UNITED STATES PATENT AND TRADEMARK OFFICE

APPLICATION NO.	FILING DATE	FIRST NAMED INVENTOR	ATTORNEY DOCKET NO.	CONFIRMATION NO.
10/814,883	03/31/2004	Kevin J. Orvek	10559-932001	7571
20985	7590	03/31/2006	EXAMINER	
FISH & RICHARDSON, PC P.O. BOX 1022 MINNEAPOLIS, MN 55440-1022			STARK, JARRETT J	
			ART UNIT	PAPER NUMBER
			2823

Office Action Summary

DETAILED ACTION

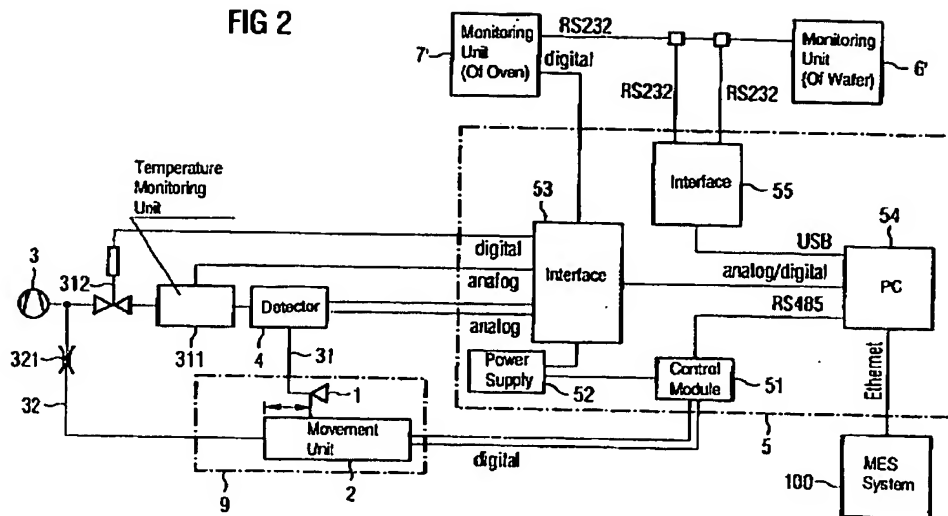
The drawings are objected to under 37 CFR 1.83(a). The drawings must show every feature of the invention specified in the claims. Therefore, the "critical pitch" must be shown or the feature(s) canceled from the claim(s). No new matter should be entered.

From the specs, drawing, and claims it is unclear what a "critical pitch" is. From the standard definition, pitch can be interpreted as:

- slope: be at an angle;
- degree of deviation from a horizontal plane;
- the center-to-center spacing

Corrected drawing sheets in compliance with 37 CFR 1.121(d) are required in reply to the Office action to avoid abandonment of the application. Any amended replacement drawing sheet should include all of the figures appearing on the immediate

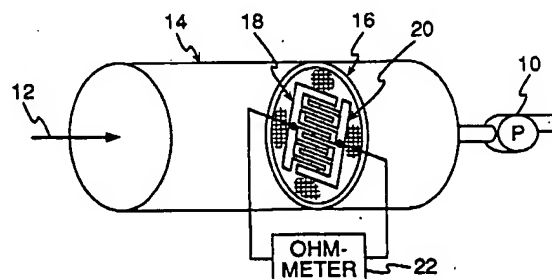
Storbeck discloses a particle detector however, does not expressly disclose the particle detecting integrated circuit including a device having a pair of exposed conductive lines spaced at a critical pitch corresponding to particles of interest.

Shah discloses the particle detecting integrated circuit including a device having a pair of exposed conductive lines spaced at a critical pitch corresponding to particles of interest. (Shah, Figure 1)
